In the Drawings

REMARKS

Figure 1A
(PRIOR ART)

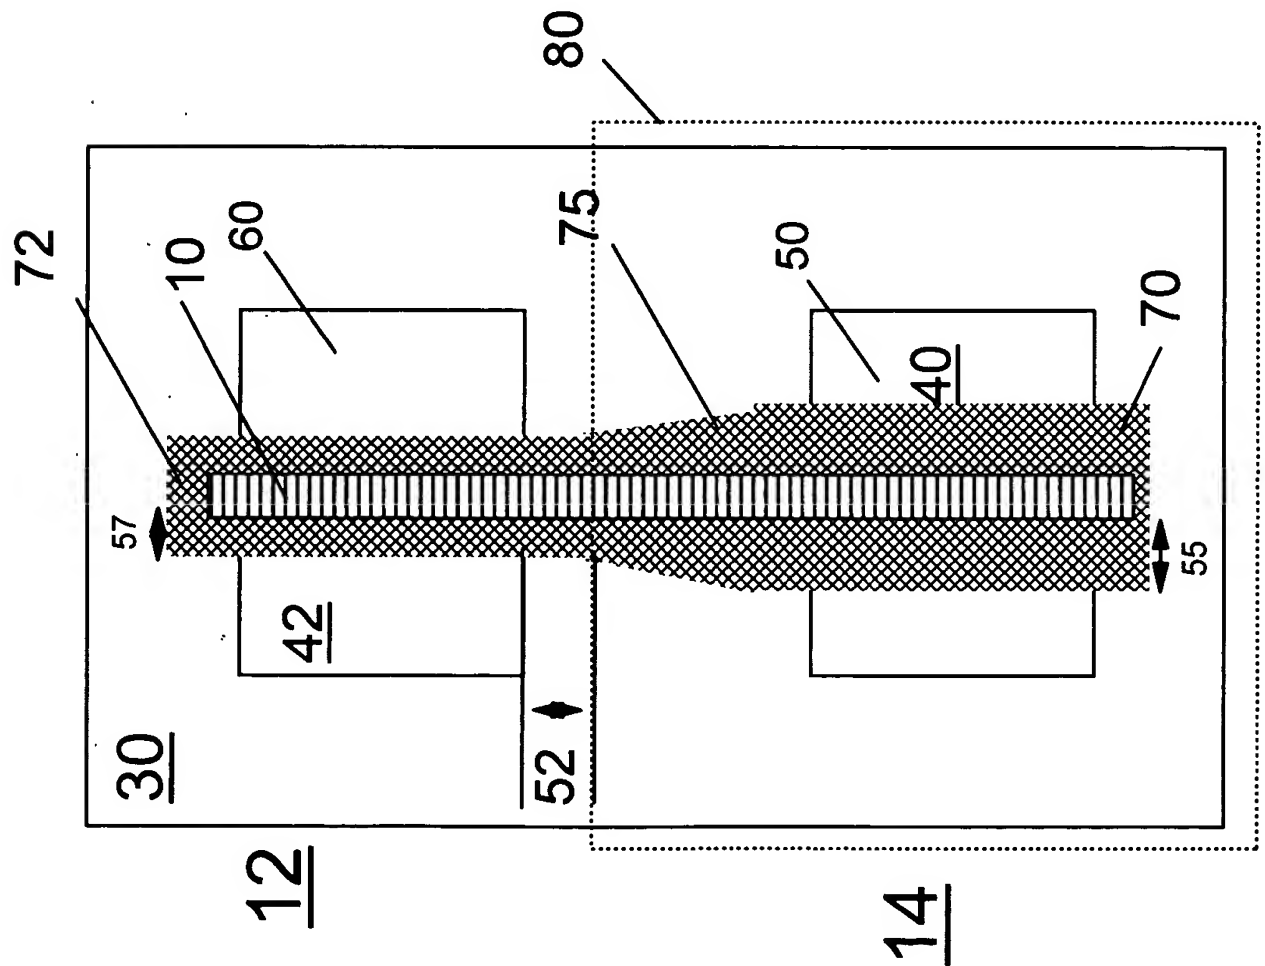
The objections to Figure 1A and claim 2 have been addressed herein by their amendment.

Please delete sheets numbered 1/12, 7/12, and 8/12 containing Figures 1A-1B, 7 and 8, respectively, and insert attached Replacement Sheets 1, 7 and 8.

Figure 7

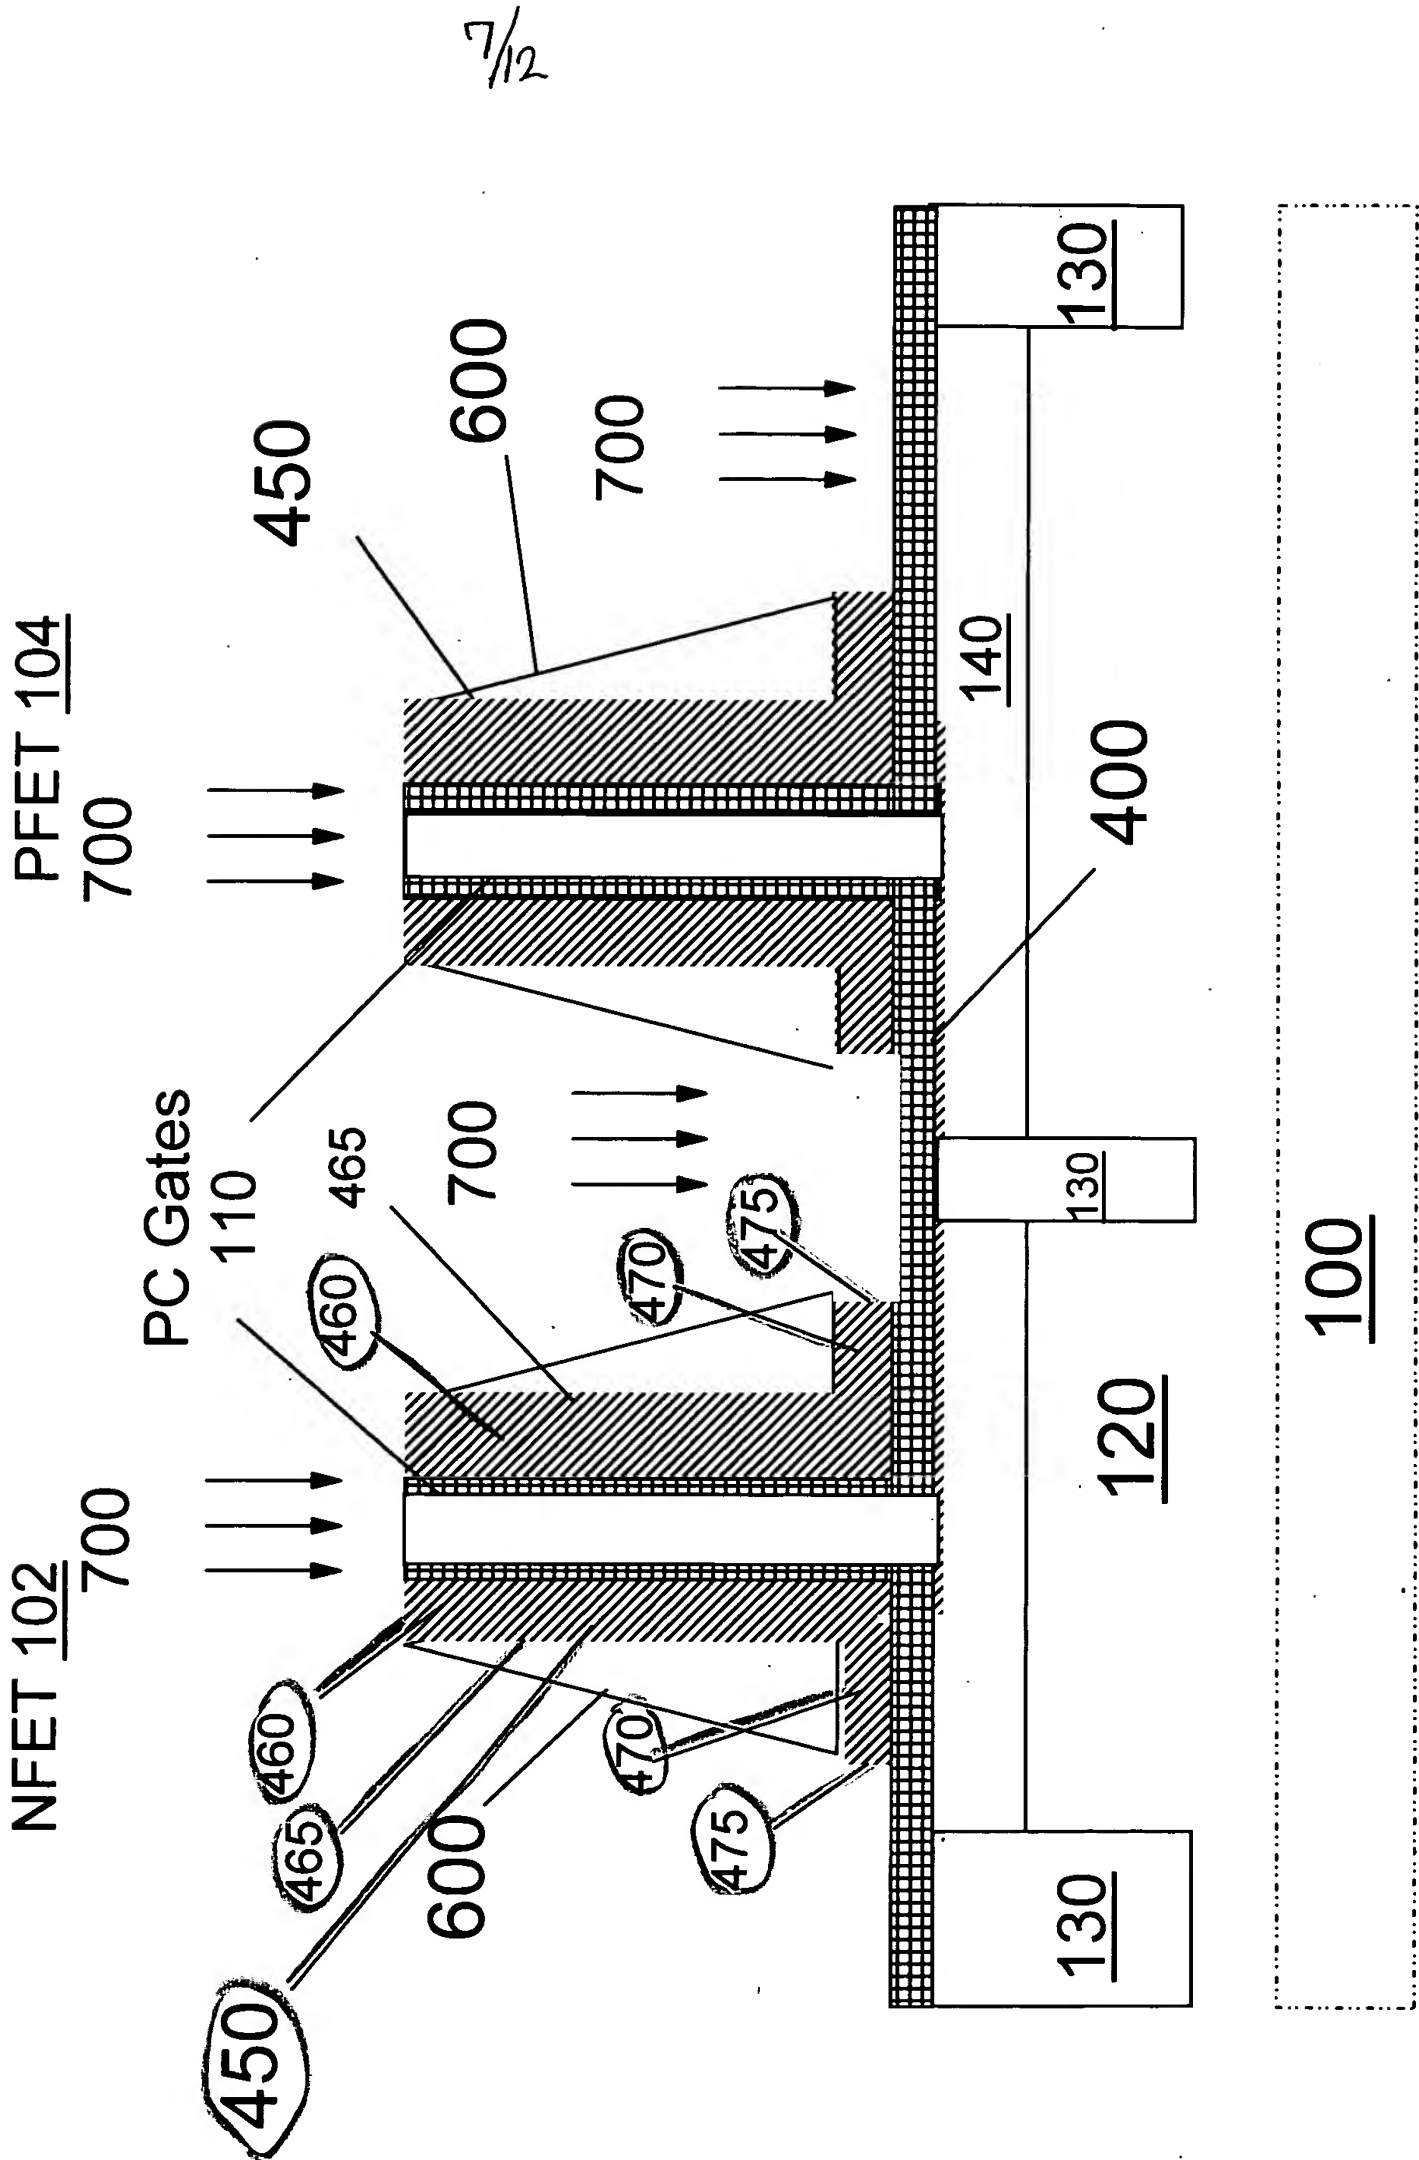
In addition, the specification and Figures 7 and 8 of the drawings are amended herein to add reference signs to features which appear in the original Figures and are supported by the original drawings and specification but were not specifically referenced before. A set of Replacement Sheets are submitted herewith together with a set of Annotated Sheets showing the changes made to the drawings. The specification is also amended accordingly. It is respectfully submitted that no new matter is contained in the present amendments.

As amended herein, claim 15 now specifies that the first spacers have an "L" shape. Being "L"-shaped, as shown in Figure 7 and as described in the specification, each first spacer includes a vertically extending portion oriented in a vertical direction,
